**UNITED STATES
NUCLEAR REGULATORY COMMISSION**
WASHINGTON, D.C. 20555-0001

**SUBJECT: PALO VERDE NUCLEAR GENERATING STATION, UNITS 1, 2, AND 3 -
ISSUANCE OF AMENDMENTS RE: REQUEST FOR AMENDMENT TO
VARIOUS TECHNICAL SPECIFICATIONS TO IMPLEMENT ADMINISTRATIVE
CHANGES (TAC NOS. ME7621, ME7622, AND ME7623)**

SAFETY EVALUATION BY THE OFFICE OF NUCLEAR REACTOR REGULATION
RELATED TO AMENDMENT NOS. 189, 189, AND 189 TO RENEWED FACILITY
OPERATING LICENSE NOS. NPF-41, NPF-51, AND NPF-74
ARIZONA PUBLIC SERVICE COMPANY, ET AL.
PALO VERDE NUCLEAR GENERATING STATION, UNITS 1, 2, AND 3
DOCKET NOS. STN 50-528, STN 50-529, AND STN 50-530

FIGURE 3.5.5-1
Minimum Required RWT Volume

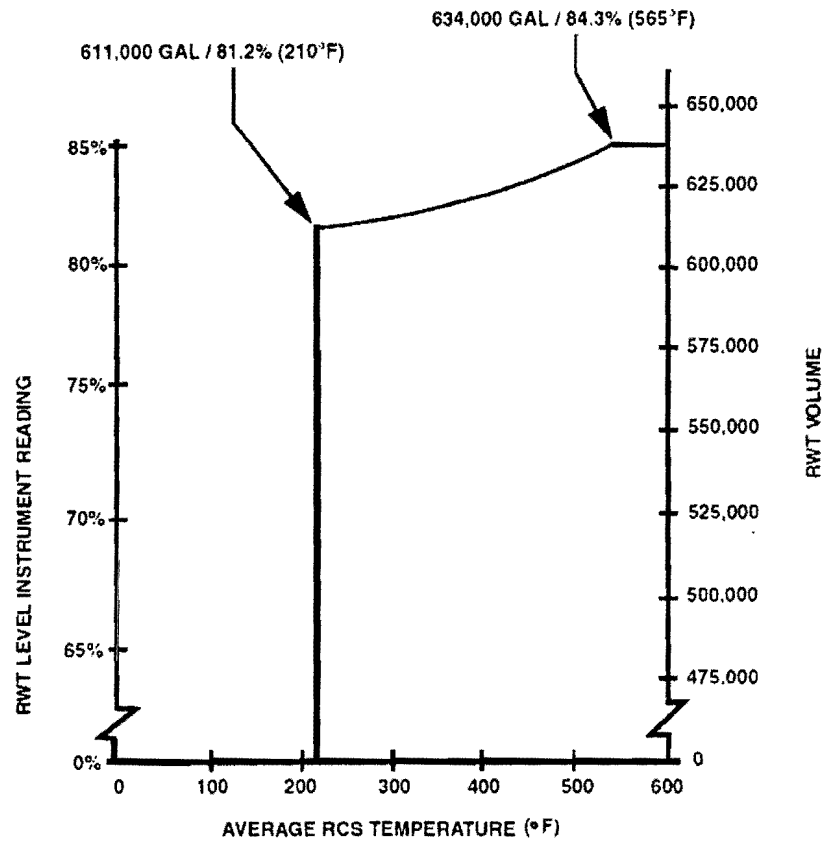
APS is proposing to delete the pre-RWT [refueling water tank] TS setpoint change Table 3.3.5-1 and Figure 3.5.5-1. In addition, APS will remove the words "After RWT TS Setpoint Change," from the remaining versions of Table 3.3.5-1 and Figure 3.5.5-1 and renumber the TS pages. License Amendment No. 182 dated November 24, 2010 (Reference 2), revised Table 3.3.5-1 of TS 3.3.5, "Engineered Safety Features Actuation System (ESFAS) Instrumentation," to raise the RWT low level allowable value for the recirculation actuation signal; raised the minimum required RWT volume shown in Figure 3.5.5-1 of TS 3.5.5, "Refueling Water Tank (RWT)"; and implemented a time-critical operator action to close the RWT isolation valves. APS completed these modifications to Palo Verde, Units 1, 2, and 3, and the "After RWT TS Setpoint Change" allowable values are now fully implemented in Palo Verde, Units 1, 2, and 3. As a result, the "Pre-RWT TS Setpoint Change" versions of the tables are no longer applicable to Palo Verde, Units 1, 2, and 3. This change removes information that is no longer applicable at Palo Verde,
